# WATERBURY SANITARY FORCE MAIN

# UTILITY CONSTRUCTION SET

## JULY 2026

UTILITY CONSTRUCTION SET  
COVER SHEET

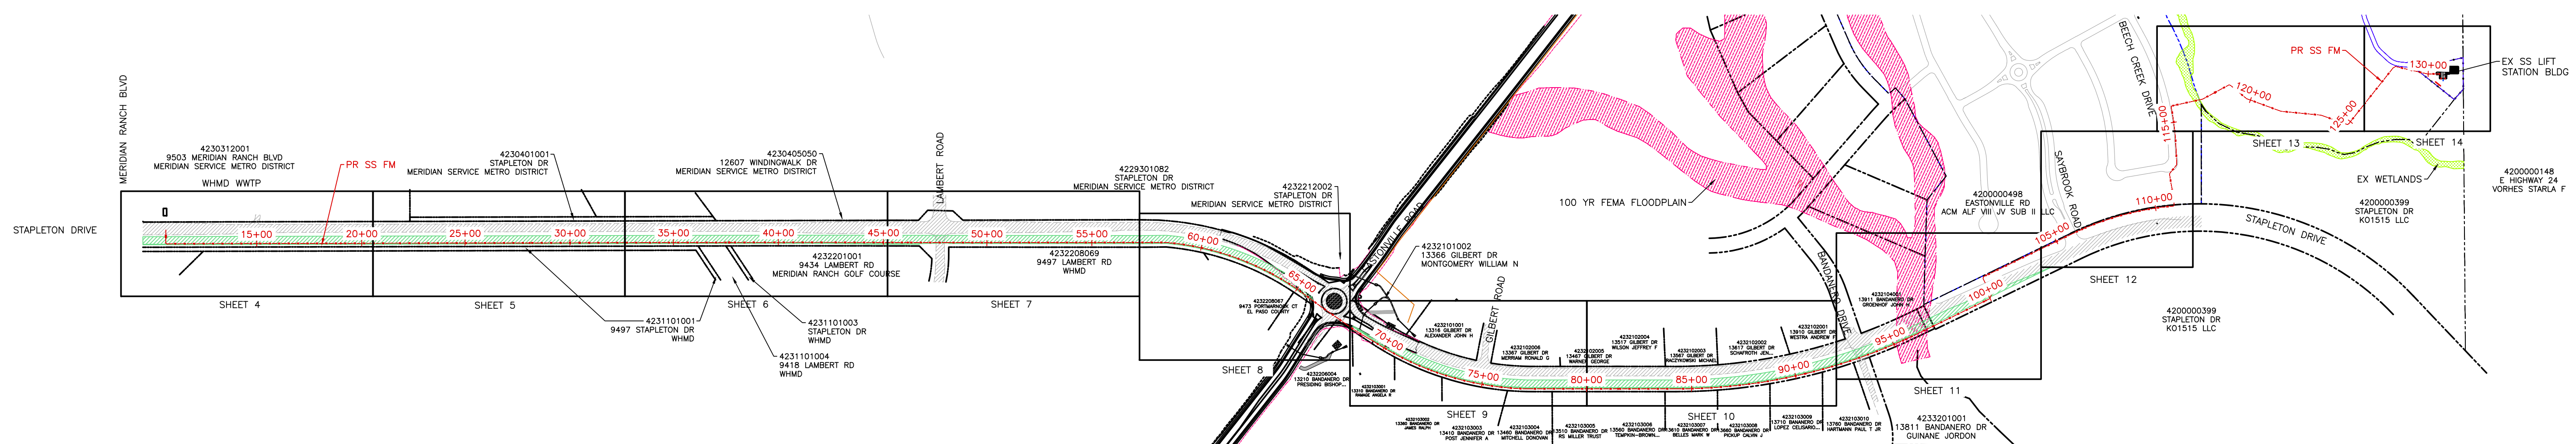
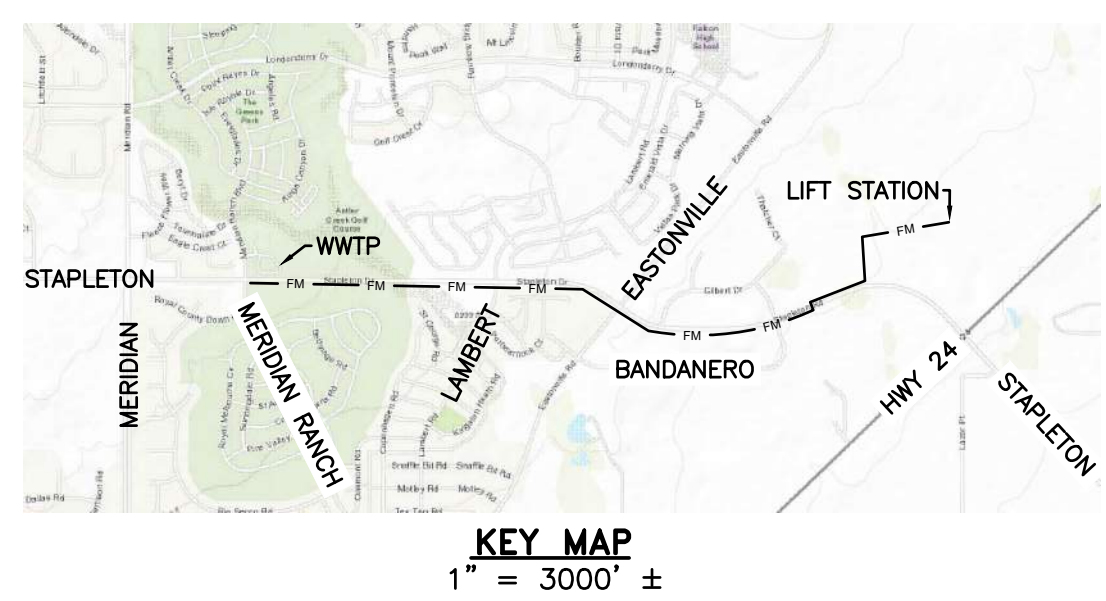
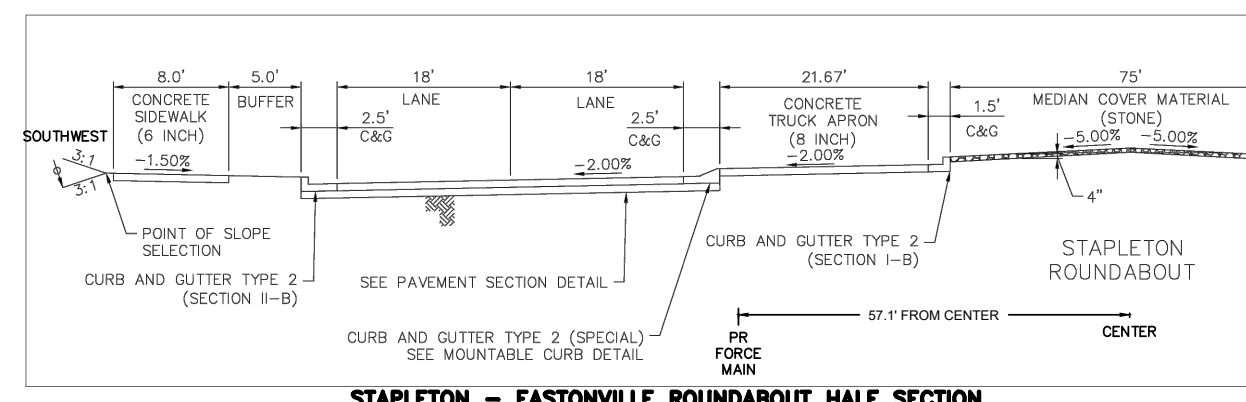
Please show and label the Center Line CL for the Street for all sections shown above and all plans on all sheets.
